CONSTRUCTION PLANS
FOR
**CARRIAGE MEADOW SOUTH AT
LORSON RANCH FILING NO. 2**
STREET/STORM SEWER AND UTILITY CONSTRUCTION PLANS

Engineering Review

COVER SHEET

CARRIAGE MEADOWS SOUTH AT LORSON RANCH FIL. NO. 2 HORIZONTAL CONTROL PLAN

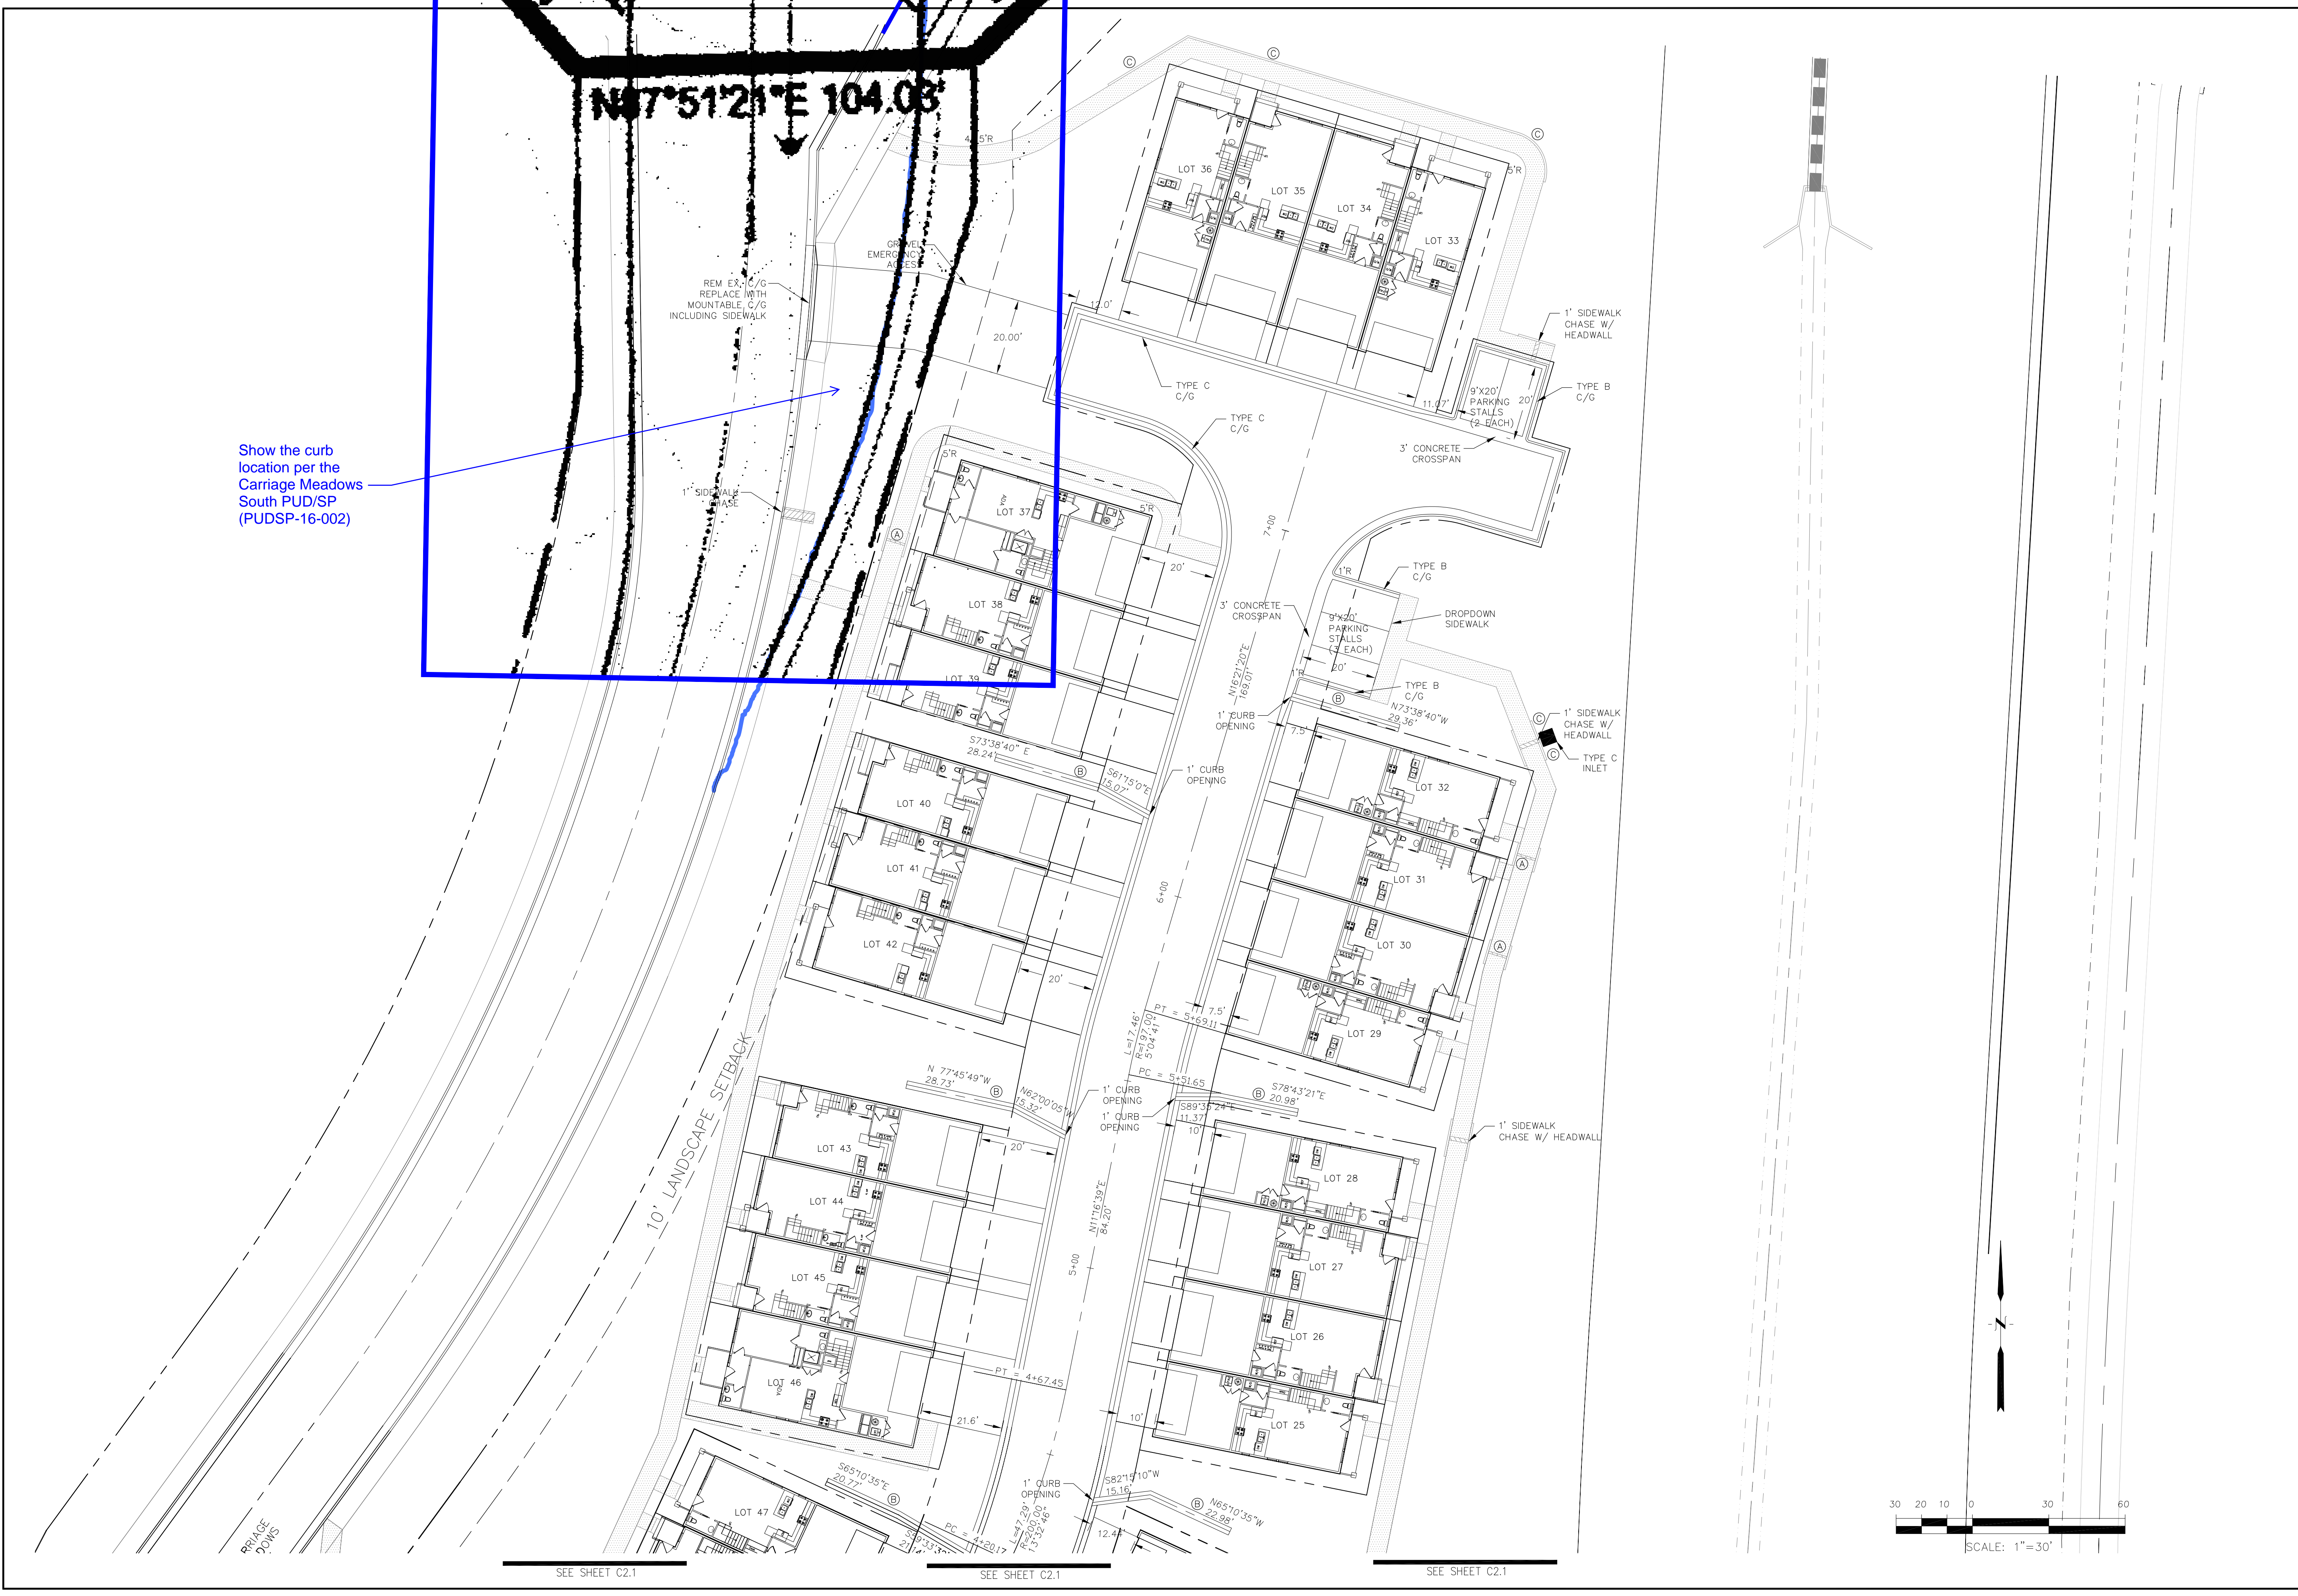
Show the curb location per the Carriage Meadows South PUD/SP (PUDSP-16-002)

SIGNING PLAN
CARRIAGE MEADOWS SOUTH AT
LORSON RANCH FILING NO. 2

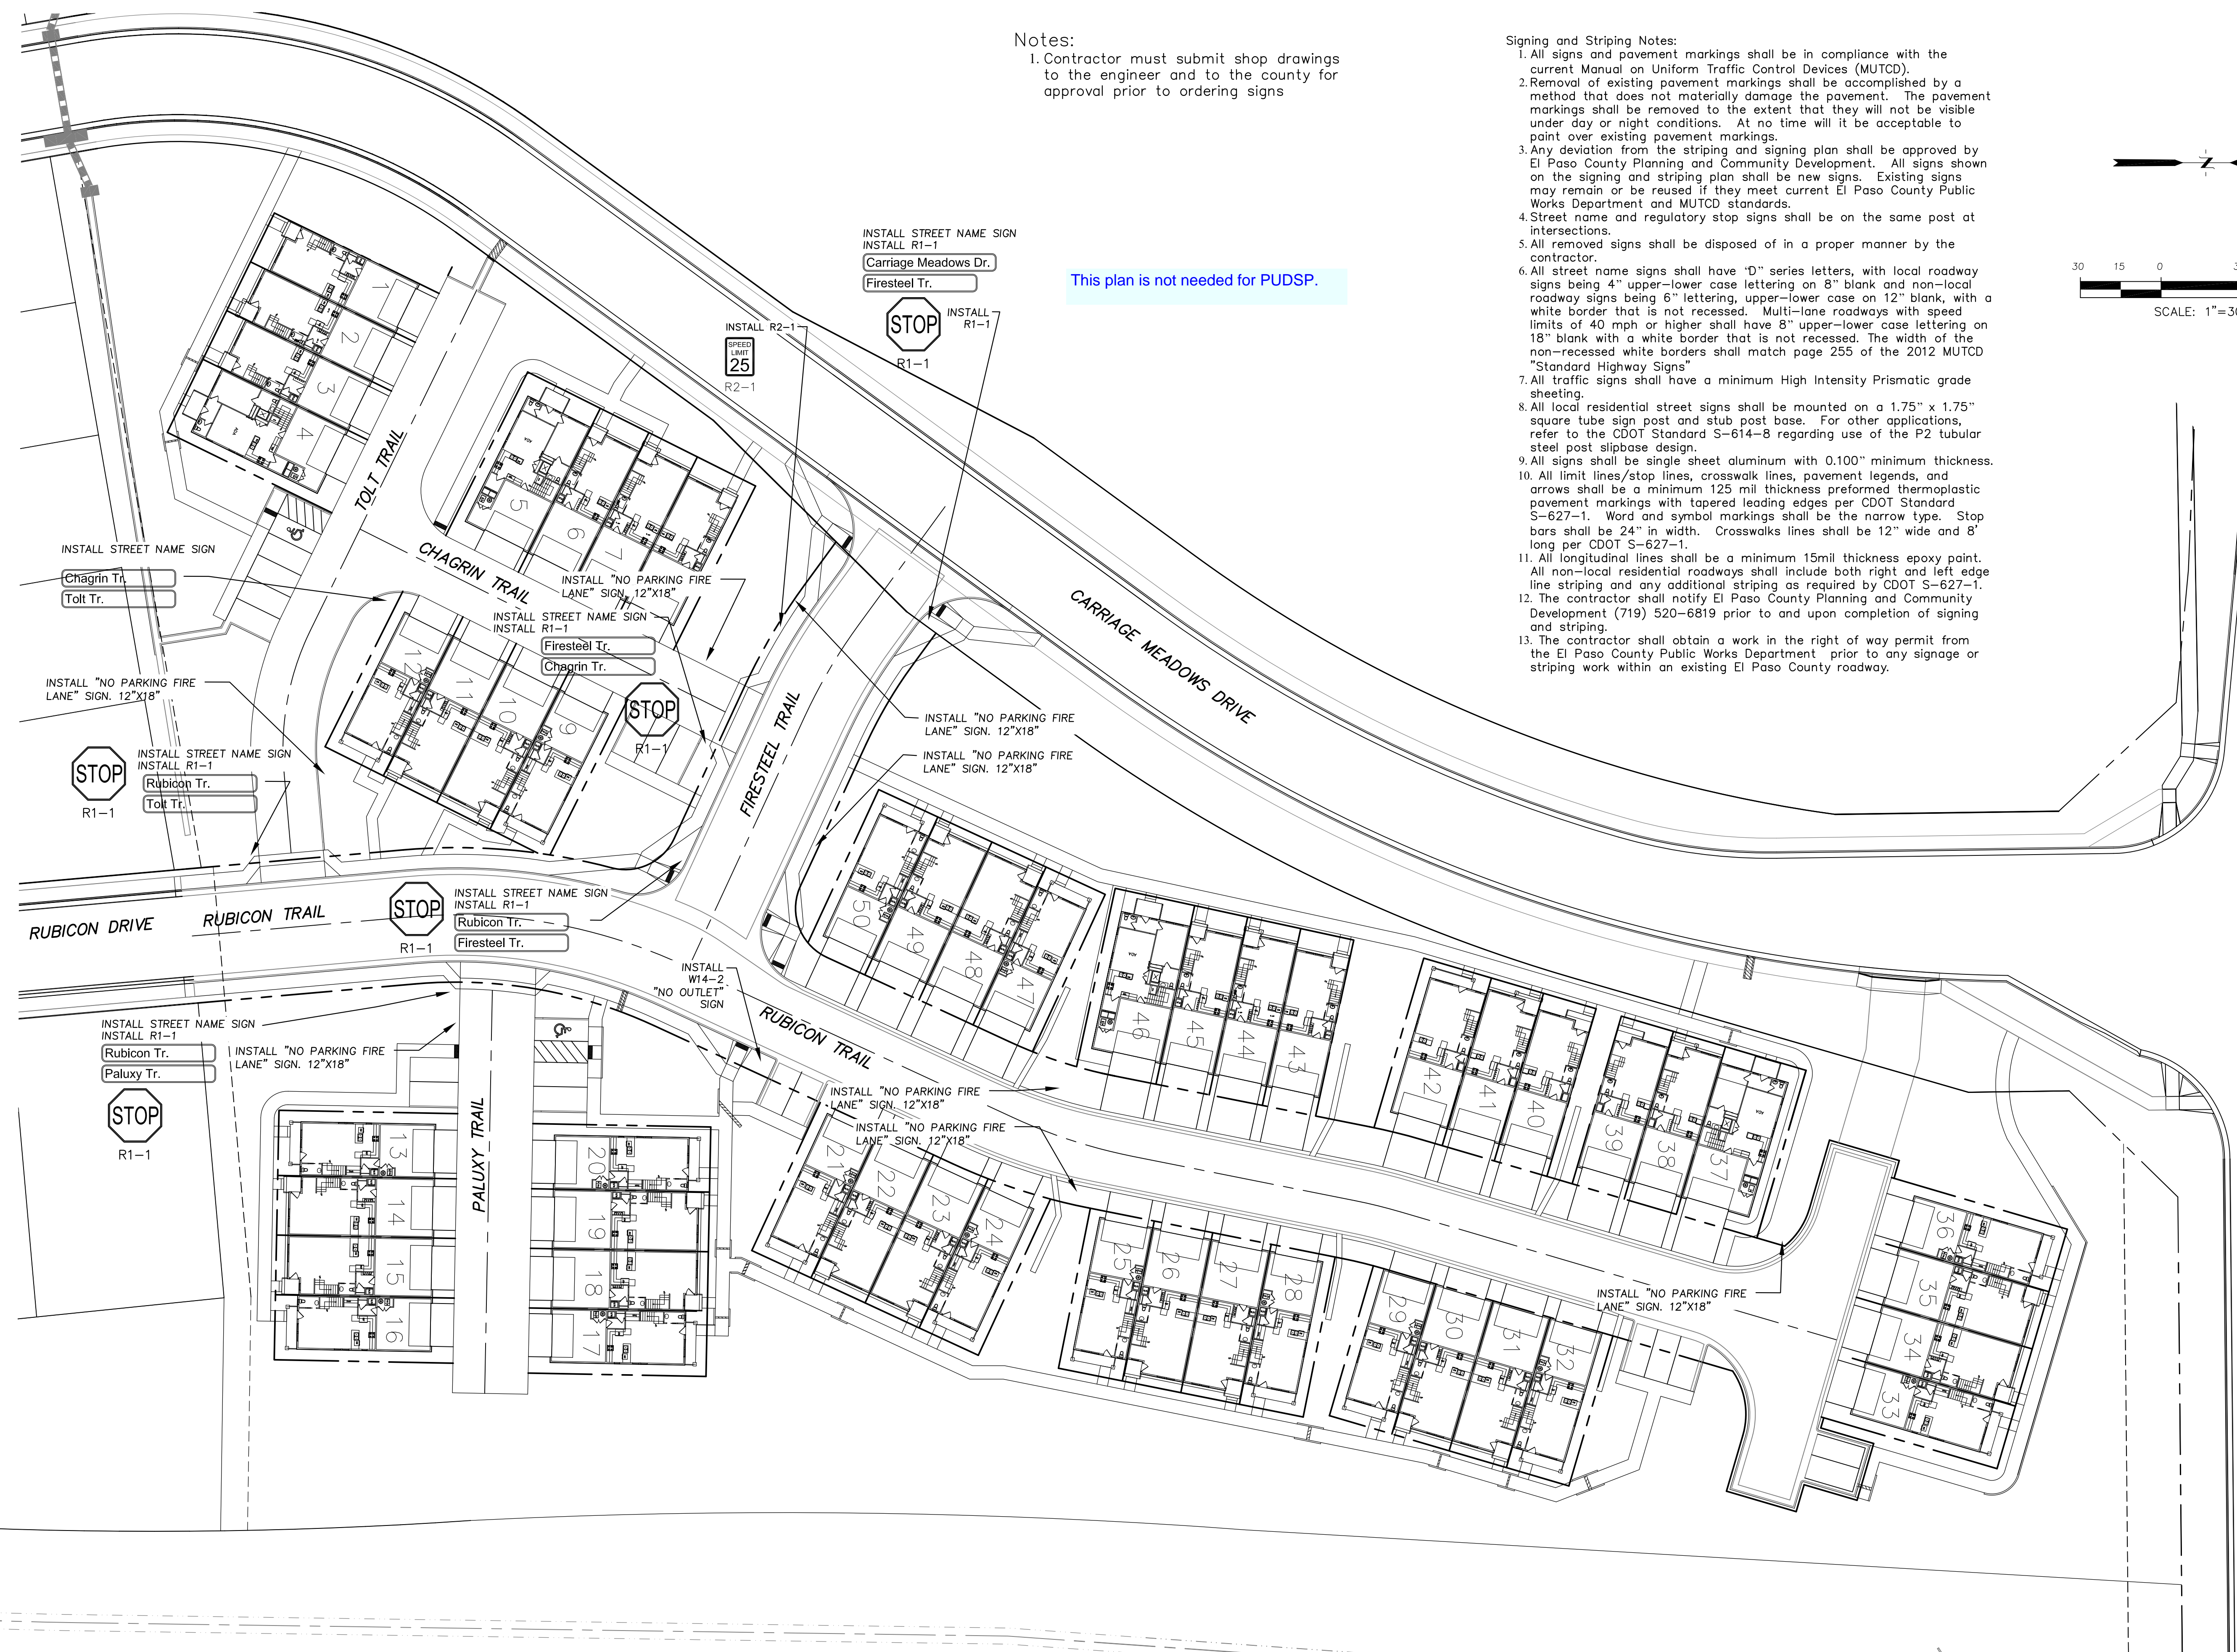
This plan is not needed for PUDSP.

STREET/STORM
FIRESTEEL TRAIL
STA 0+00 TO 2+50

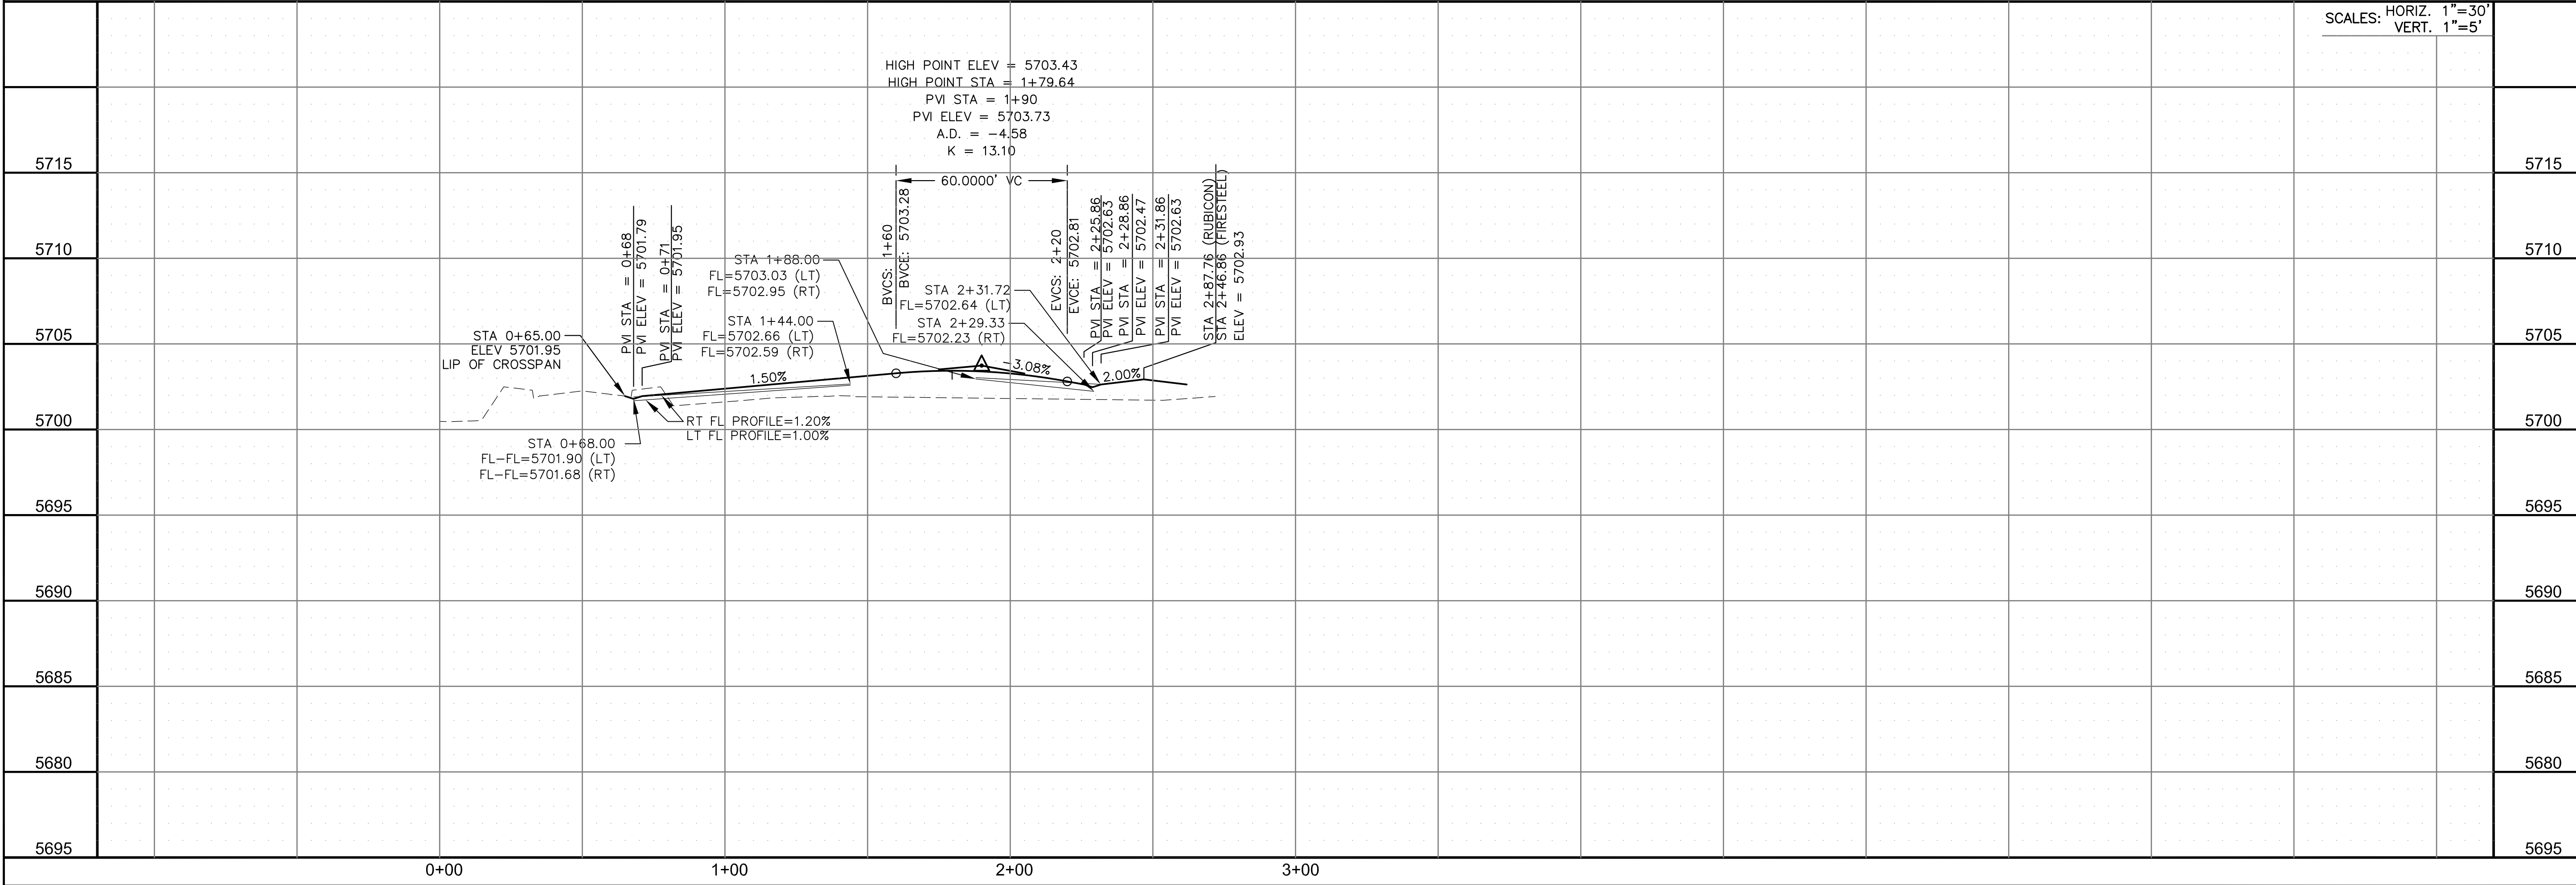
FIRESTEEL TRAIL add "Public" or "Private Road"
